## PRODUCT CHANGE NOTIFICATION

### #PCN-IFC-Z5WC-14

<b>Business Unit</b>	Product Line Code	Type of Change	Action	Date of issue
IFC	BF7	Aesthetic	Notify Distributors and Field	9/4/2014

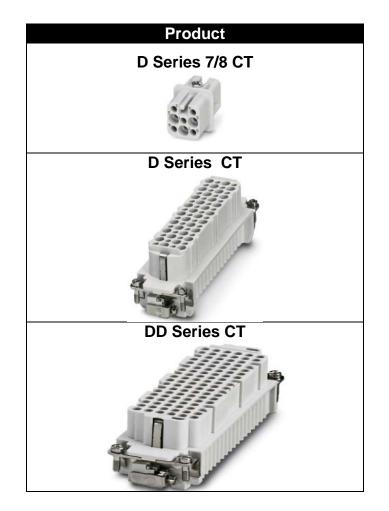
The insert material has been changed from Polyamide (PA) to Polycarbonate (PC). This change was made to reach higher crimp retention forces. The product color did not change and the agency certifications are still valid.
